Consensus proposal for training state diagram

(supporting comments 118, 101, and 19)

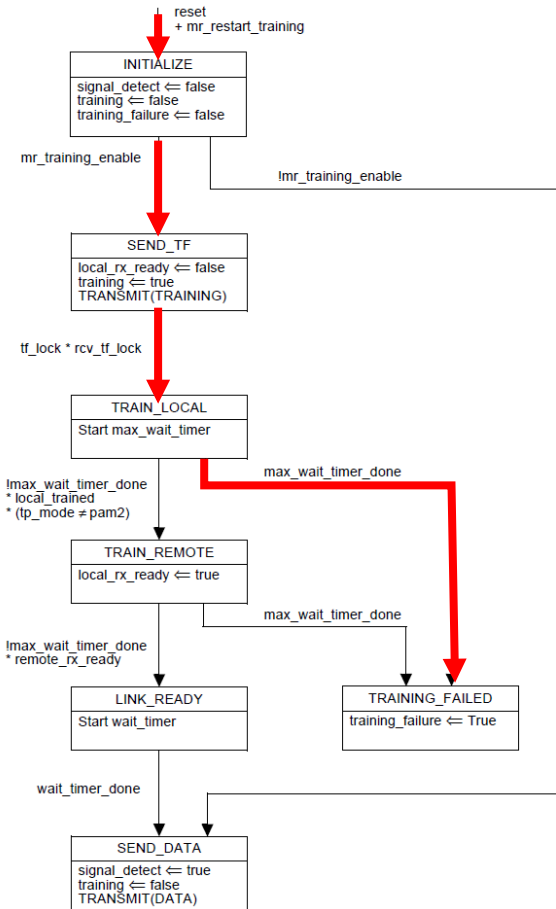
The state diagram – problem statement

- If one side gets to **TRAINING_FAILED**, it will cause the other side to also land there
 - With both sides transmitting TFs
- Existing this state is tricky...
 - Resetting only side A while side B is in **TRAINING_FAILED** would result in side A landing back in **TRAINING_FAILED** after `max_wait_timer`.
- You need to reset both sides within a short period
 - May not be feasible in a distributed environment...

New proposal

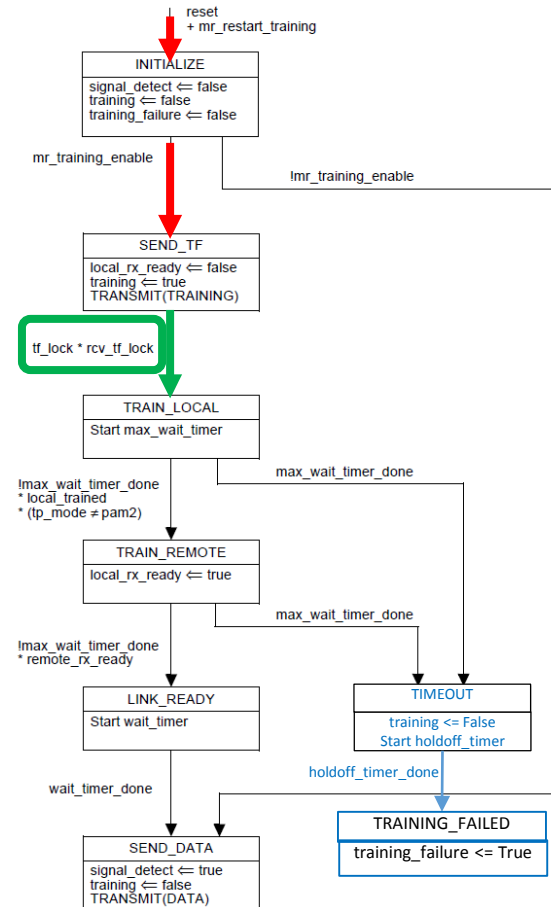
- Based on suggested remedy to comment #19
 - Desire is to prevent losing the frame alignment in TRAINING_FAILED
- Instead of resetting the frame lock state diagram (Figure 136-8), we can just stop reporting to the partner that we are locked, by changing the definition of tf_lock to include the “training” state

- This change will keep the frame alignment, but the partner will see “remote_tf_lock=false” until TRAINING_FAILED is exited (by reset)
 - After one partner is reset, it may re-lock, but it will stop in SEND_TF while partner is still in TRAINING_FRAME

- The two partners need to “meet” by both being in SEND_TF, and reporting lock state to each other. Then they start their timers together
- To prevent deadlock if reset is asserted too quickly, add a timer to hold off asserting training_failure

- Timer should be longer than the variation of max_wait_timer, which is ± 30 ms
- Proposal: update the PMD control state diagram based on the diagram on the right. Change clause text as shown in the next slide.

- In 136.8.12.7.1, change the definition of tf_lock
 - FROM “Boolean variable that is true when the training frame marker positions have been identified and is false otherwise”
 - TO “Boolean variable that is true if the value of training is true and training frame marker positions have been identified, and is false otherwise”
- In 136.8.12.7.3, add new timer
 - holdoff_timer: This timer is started when the PMD control state diagram enters the TIMEOUT state. The terminal count of this holdoff_timer is 40 ms \pm 2%.
